Pentavia, Mill Hill

Planning Addendum
May 2019

GLA COMMENTS SUMMARY

Comments 3.3 and 3.4 - Updated Overall Plan (Ground Floor) with revised ground floor defensible planting areas, public realm and supporting metal balcony frame structures

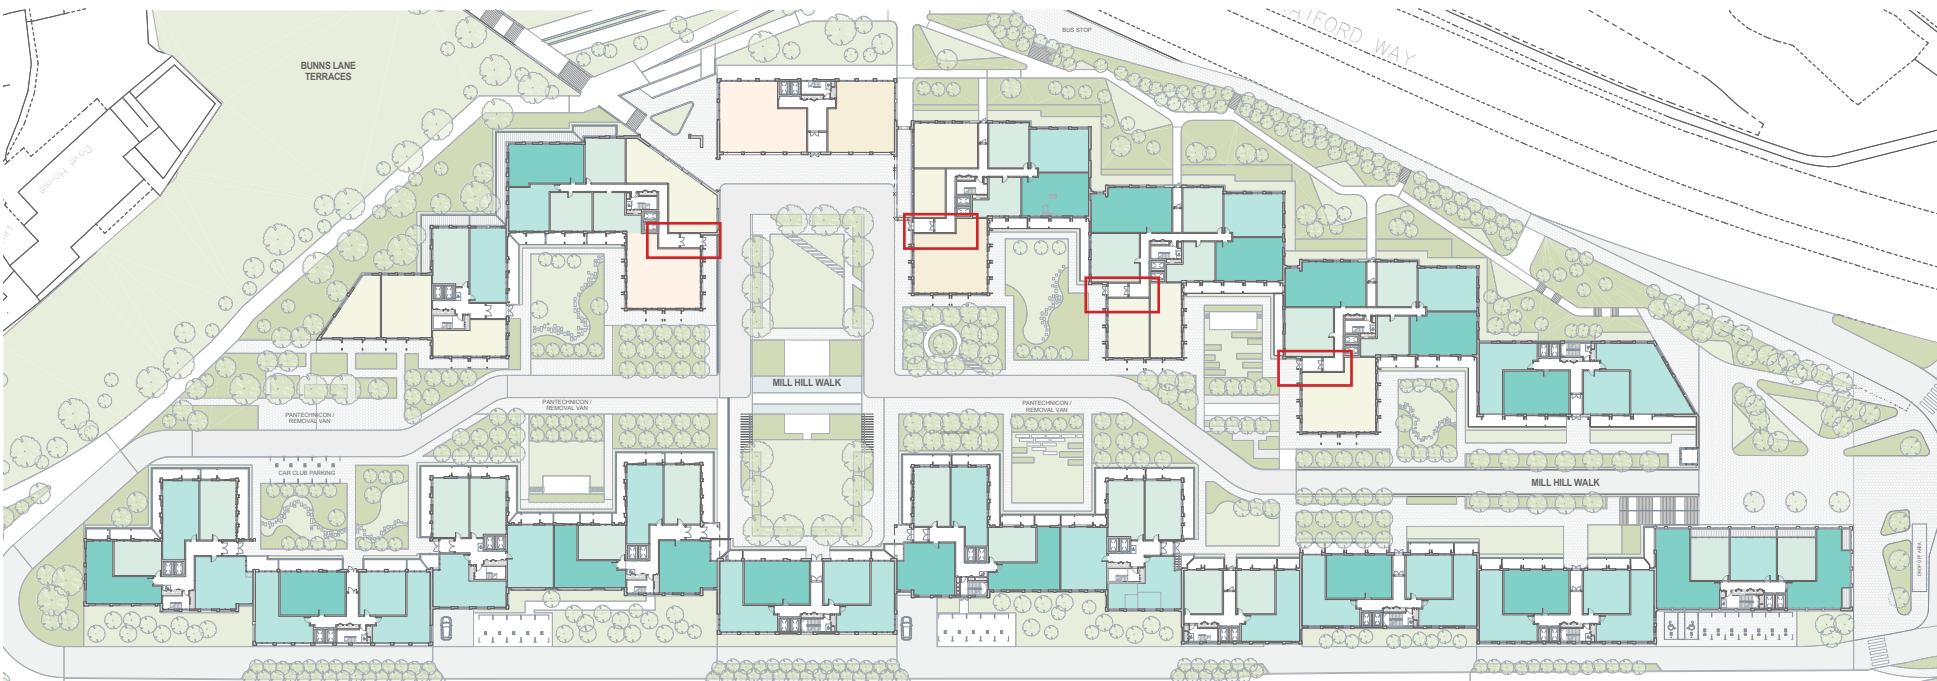
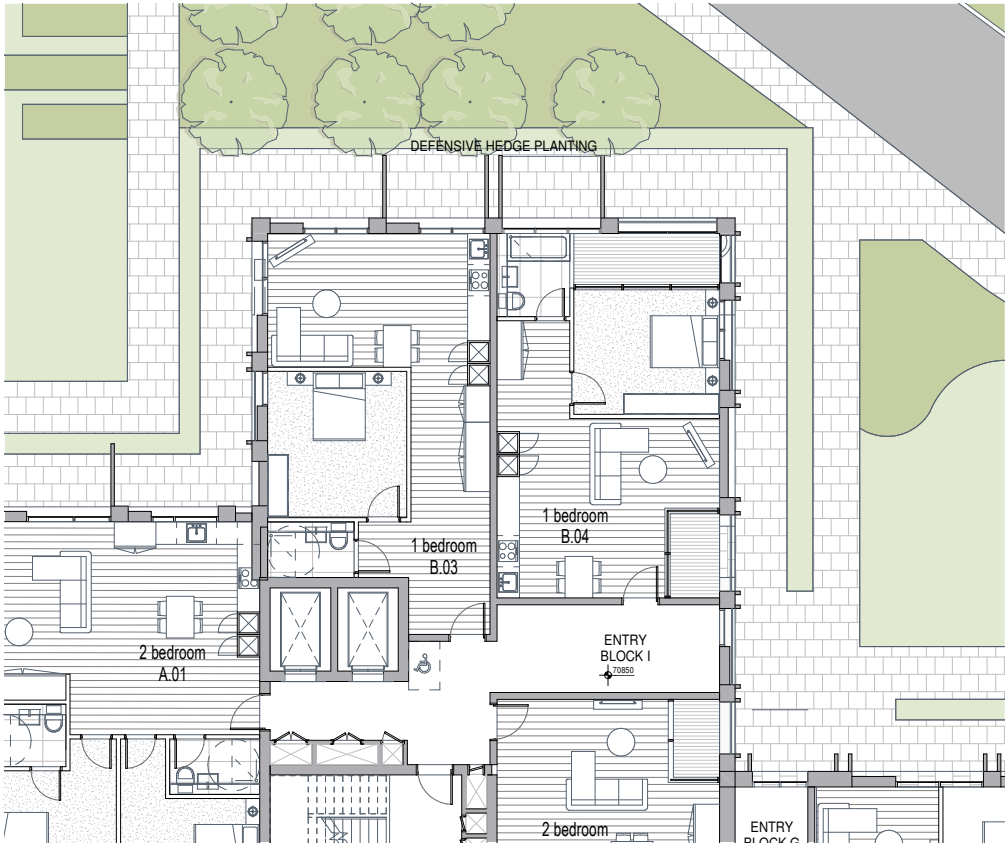
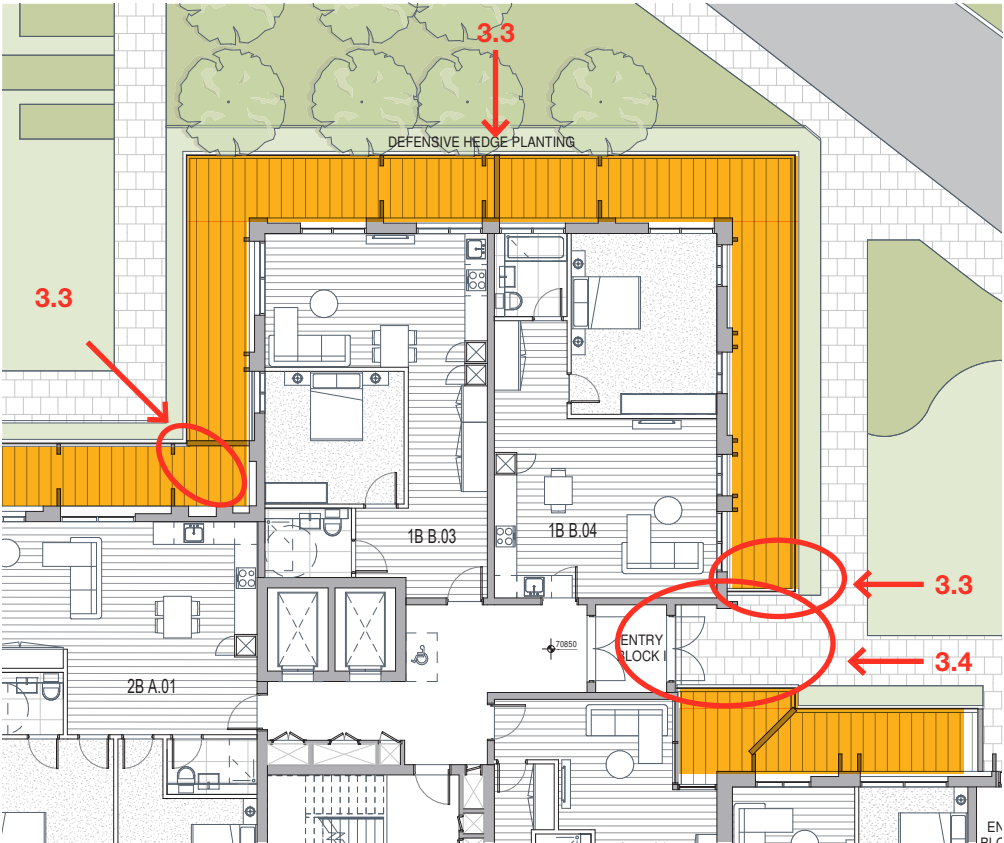
- According to the submitted floorplans, it is very unclear whether the ground floor units would have ownership of the adjacent spaces which are bounded by defensible hedge planting. These spaces are not appropriately partitioned to serve individual units and would not provide a clear definition between private and public/communal space.
- There are many instances where these defensible spaces are shared by a number of units with fronting bedrooms which is not appropriate for privacy reasons and the space should be divided and landscaped to ensure the ownership and role of this space is clearly defined.

- Areas of this landscaping strip should be finished off, next to residential core entrances, to clearly define private and public space.

- This has been further defined to each unit

- This has been further defined to each unit

Comments 3.5, 3.6, and 3.7 - Updated Overall Plan (Ground Floor)

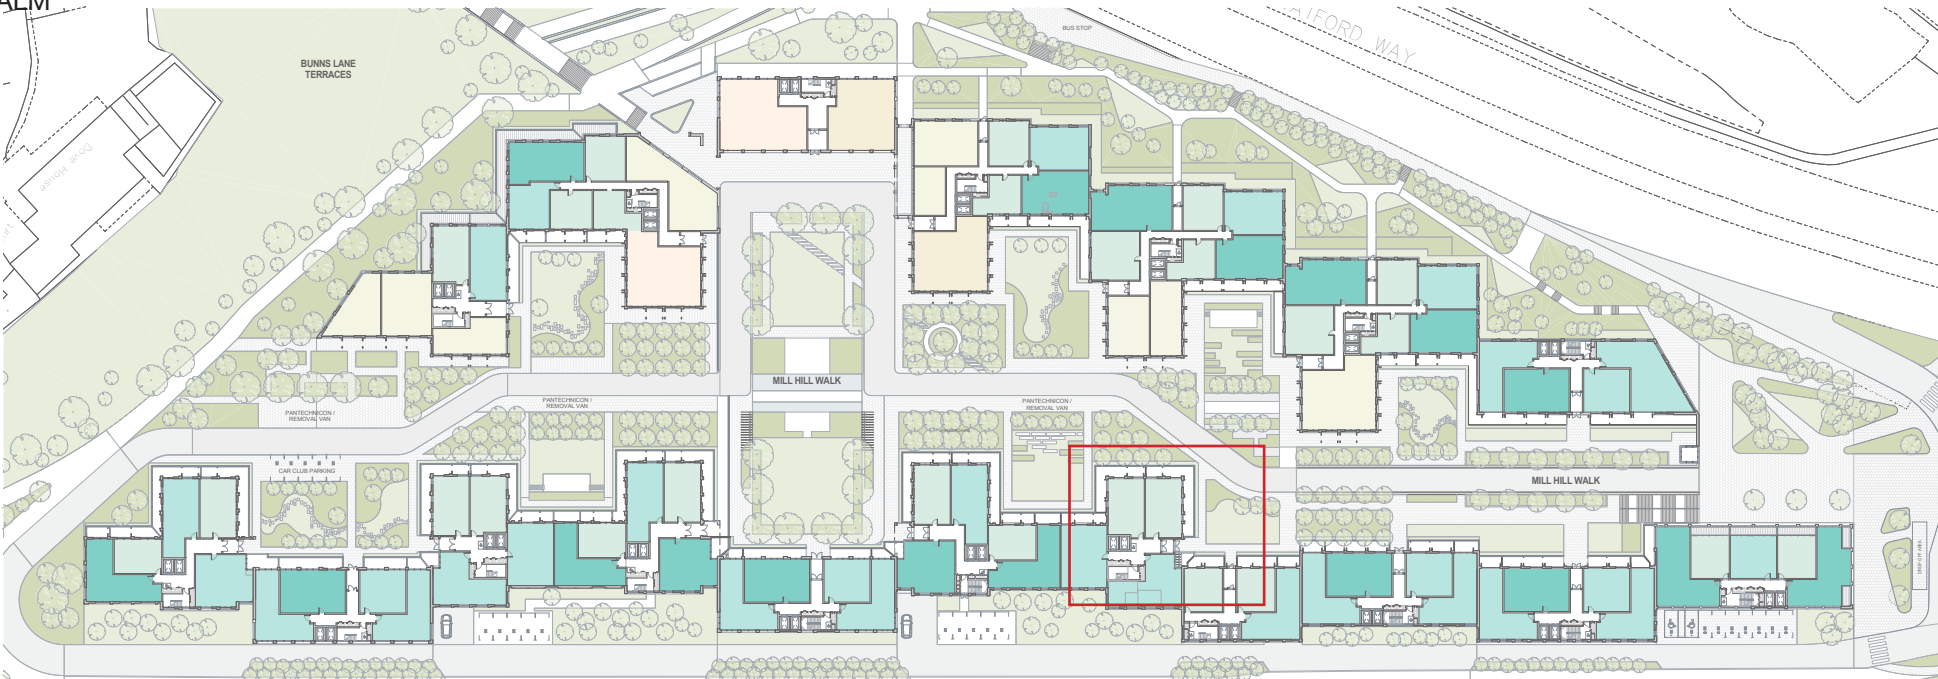
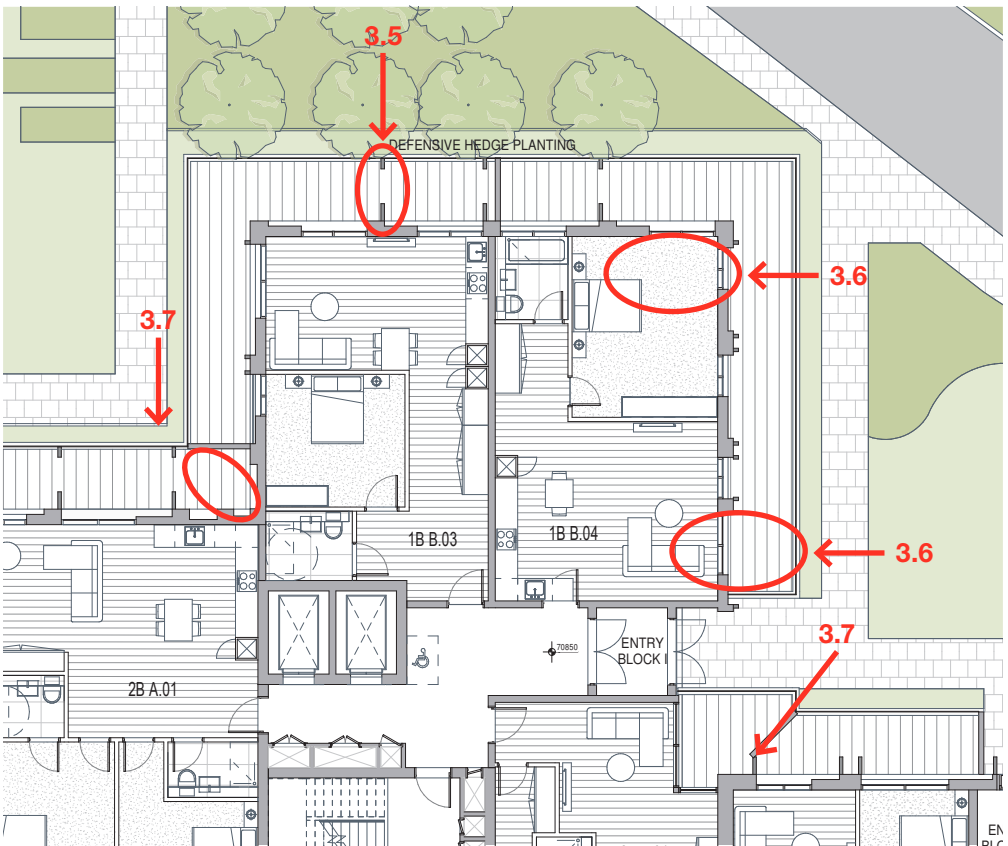
- An excessive number of supporting metal frame/ panel structures are placed in these linear defensible spaces. These appear to support balconies and winter gardens on the floor above and would effectively split up and compromise the use of these spaces by the adjacent residential units. These structures should be replaced with single free-standing columns to ensure these amenity spaces function as usable terraces for residents, as illustrated on page 68 of the D&A statement. The purpose of the metal frame structures is not explained in the D&A statement.

- There are a number of ground floor units on the projecting corners of blocks which have 2 balconies on the ground floor but should benefit from the use of ground floor terraces – it is unclear why this has not been provided. A more generous living room will clearly be possible in these instances.

- There are some areas in the corner of courtyards; however, where it is impossible for the adjacent unit to have private amenity space or any defensible landscape buffer, due to the proximity of units. This is an issue you will have to look at and seek to resolve, as the current arrangement is not acceptable. Examples are marked on the attached plans. This issue also affects the 3 bedroom units and is referred to above, which we have concerns about in terms of privacy, internal residential quality and daylight.

- These have been changed into free standing columns

- Space is added back to units and defensible space to the ground floor units defined

- Diagonal subdivision added to subdivide corner units

Comments 4.1 - Previous Lower Ground floor plan (Planning application drawings - March 2019)

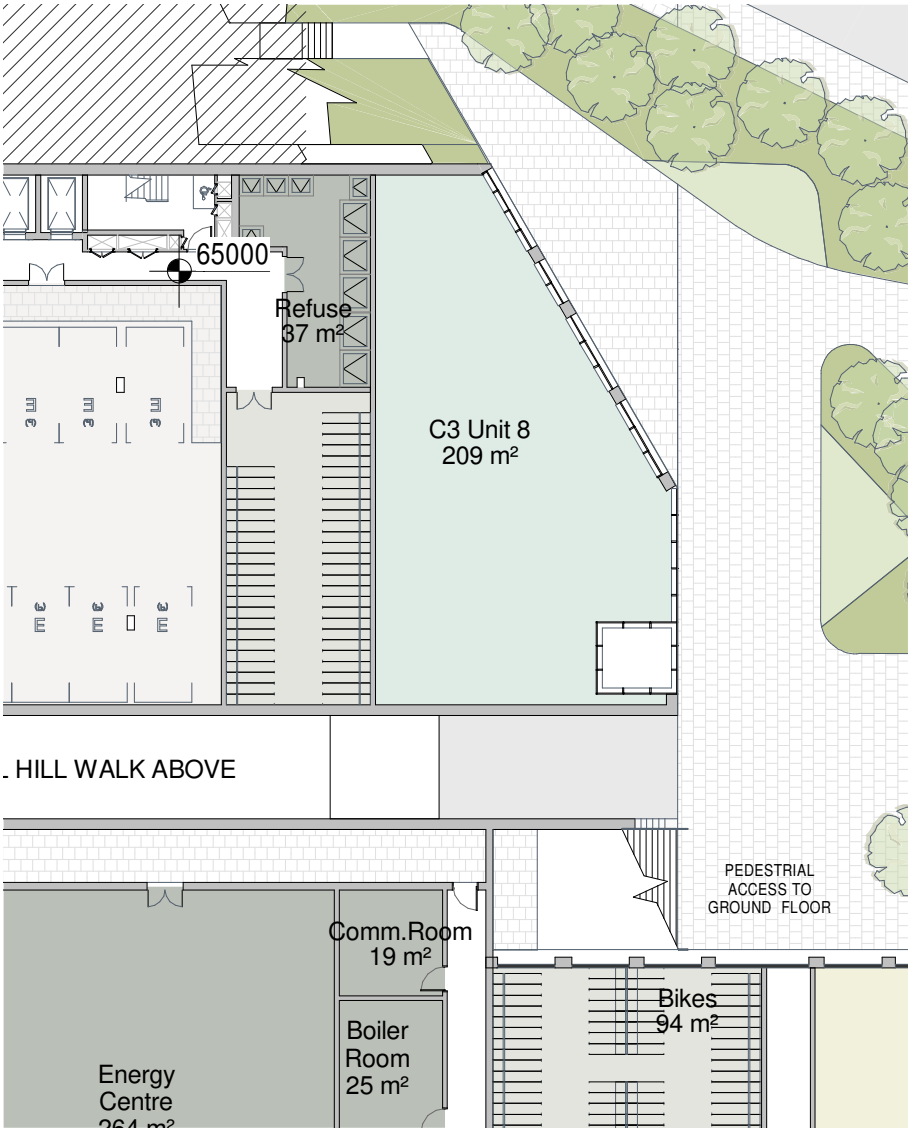
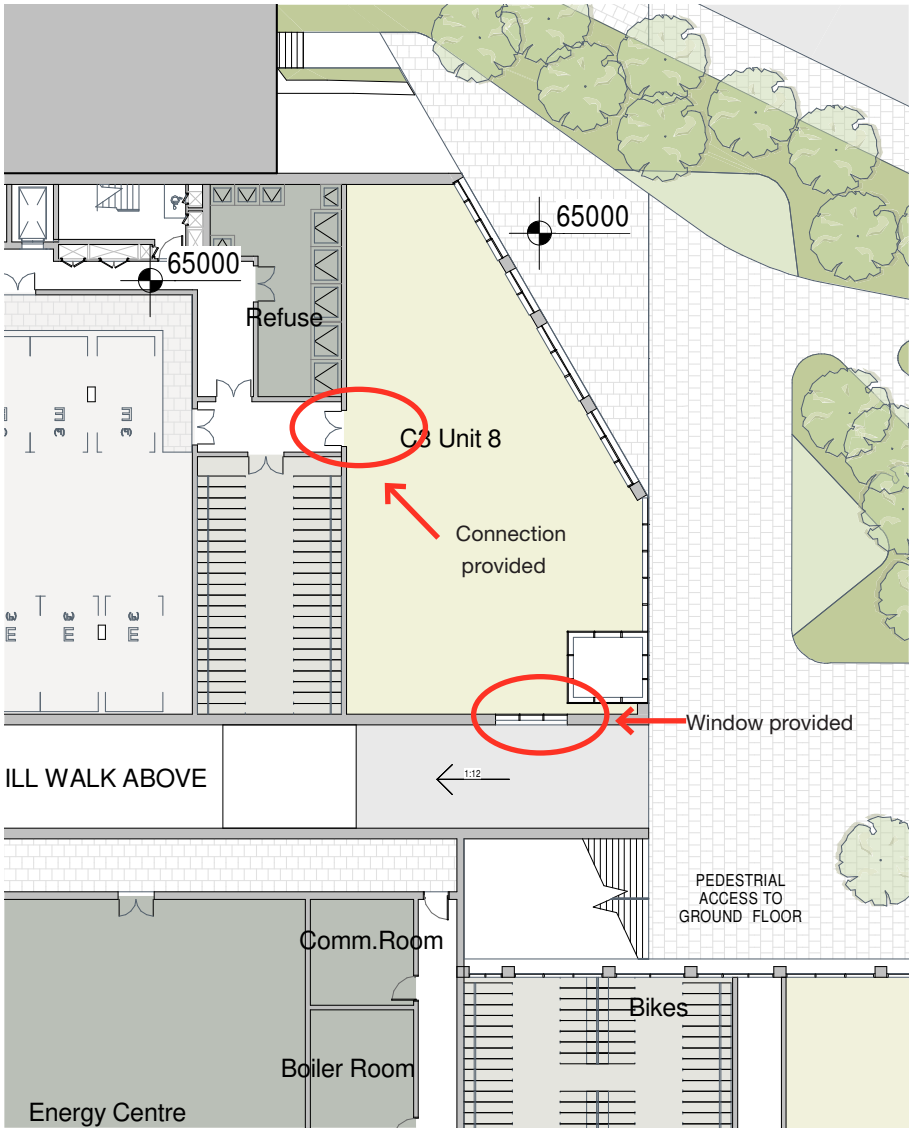
- Lower Ground floor concierge spaces is not accessible from the residential core above serving Block B and doesn't provide any active frontage along Mill Hill Walk.

- An internal corridor has been provided to the residential core in Block B
- A window onto Mill Hill Walk has been provided
